Project	IEEE 802.16 Broadband Wireless Access Working Group < http://ieee802.org/16 >	
Title	Maps Format in AAS	
Date Submitted	2004-03-16	
Source(s)	<p>Vladimir Yanover, Naftali Chayat, Tal Kaitz (Alvarion Ltd.)</p> <p>Paul Petrus, Adam Kerr (ArrayComm Inc.)</p> <p>John Liebetreu Hassan Yaghoobi, and Atul Salvekar, (Intel)</p> <p>Raja Banarjea, (Proxim)</p> <p>Bogdan Franovici, Redline</p> <p>Martin Lysejko and David Castelow, (Airspan)</p>	<p>Voice: +972-36457834 Fax: +972-36456222</p> <p>mailto:tal.kaitz@alvarion.com mailto:vladimir.yanover@alvarion.com mailto:naftali.chayat@alvarion.com</p> <p>mailto:petrus@arraycomm.com mailto:adam@arraycomm.com</p> <p>mailto:atul.a.salvekar@intel.com mailto:hassan.yaghoobi@intel.com</p>
Re:	The document supports a comment in 802.16REVd Sponsor Ballot	
Abstract	Implementation of AAS MAPs and AAS Network Entry procedure suggested	
Purpose	The document is intended for consideration during comment resolution procedure within 802.16REVd Sponsor Ballot

Maps Format in AAS

This document suggests a new structure and new FCH format for AAS zone in OFDMPHY.

Figure MMM. AAS Zone, FDD

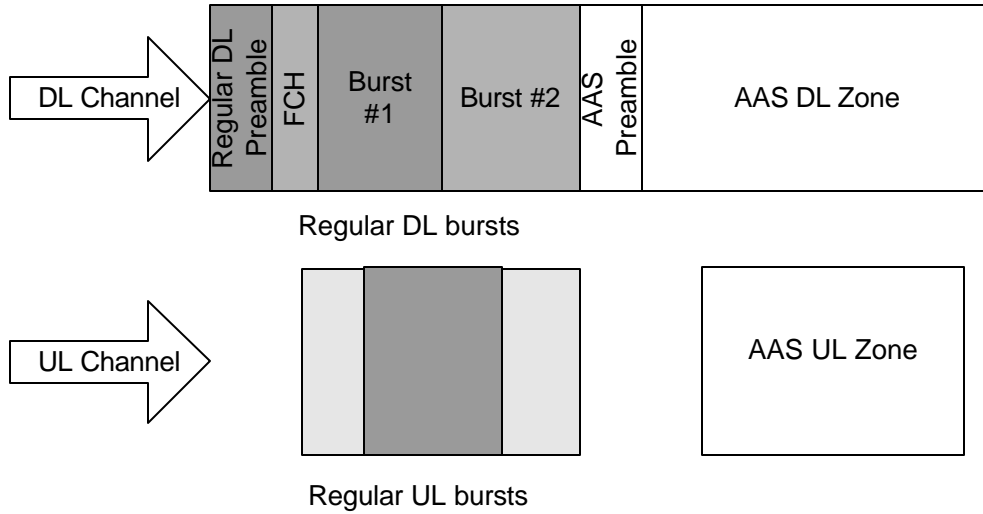
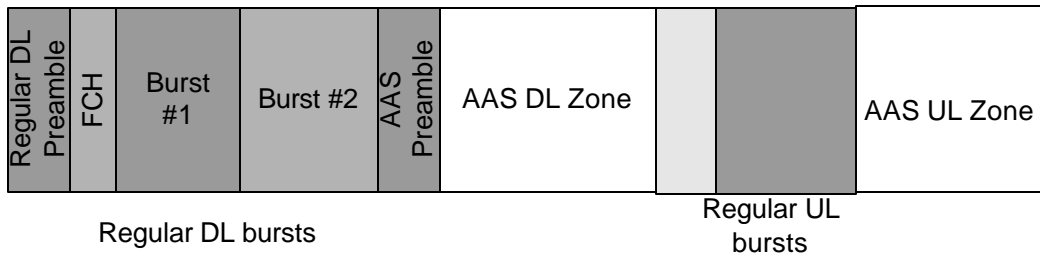
[Change in 6.4.7.6.1 “AAS MAC services”, p.160 line 41]

This is achieved by dedicating part of the frame to non-AAS traffic and part to AAS traffic. The allocation is performed dynamically by the BS. Non-AAS SSs shall ignore AAS traffic, which they can identify based on the DL-MAP/UL-MAP messages.

The AAS part of the DL frame begins with an AAS specific Preamble, see Figure MMM and Figure NNN.

For bandwidth request / allocation AAS enabled SSs may use dedicated private DL-MAP/UL-MAP messages as well as tools specific for AAS (section 8.3.4.2). BS must prevent ~~and are therefore prevented~~ AAS traffic from colliding with non-AAS traffic.

Figure QQQ. Structure of AAS Zone

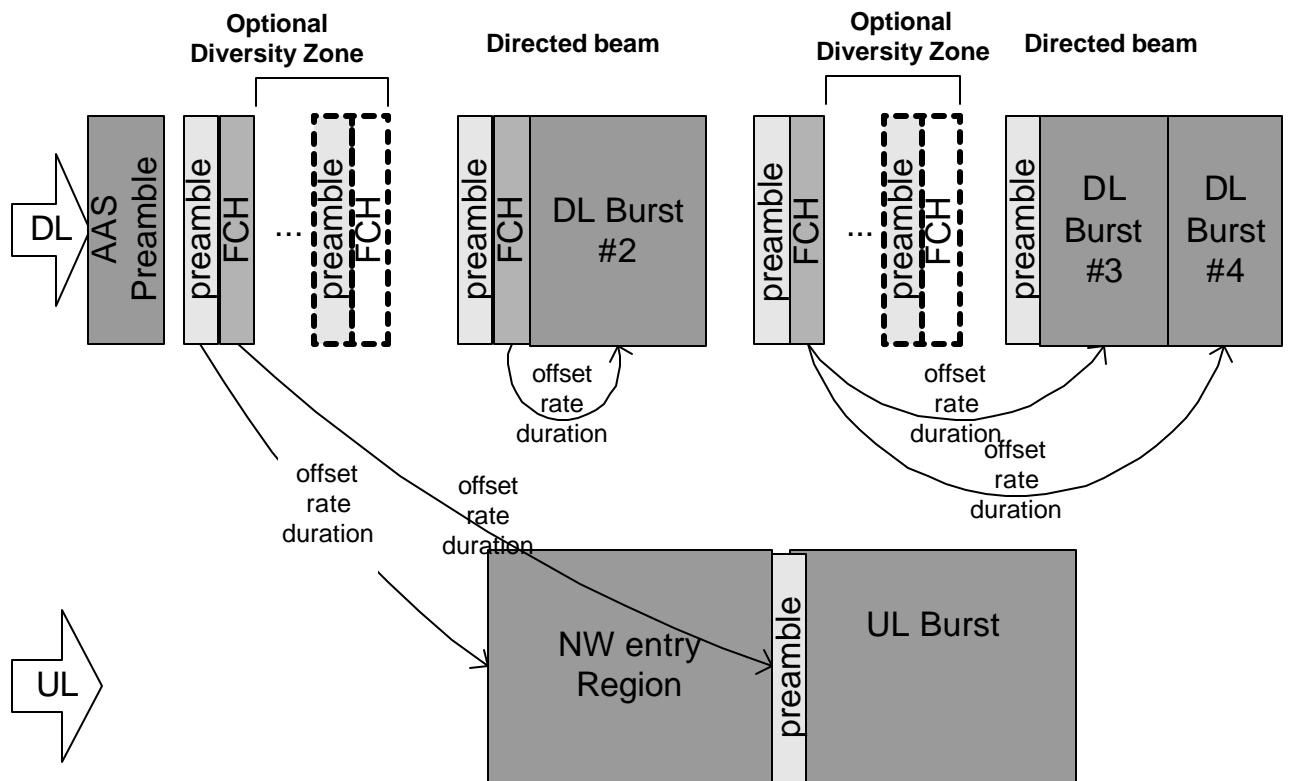
[Insert a new section after 8.3.4.1]

8.3.4.2. PMP-AAS Zone

DL transmission to an SS or group of SSs consists of two fractions. The first fraction of the transmission consists of one or several repetitions of a short preamble followed by FCH symbol (Figure 3). The second fraction is called BODY.

An example of AAS Zone layout is shown at Figure QQQ.
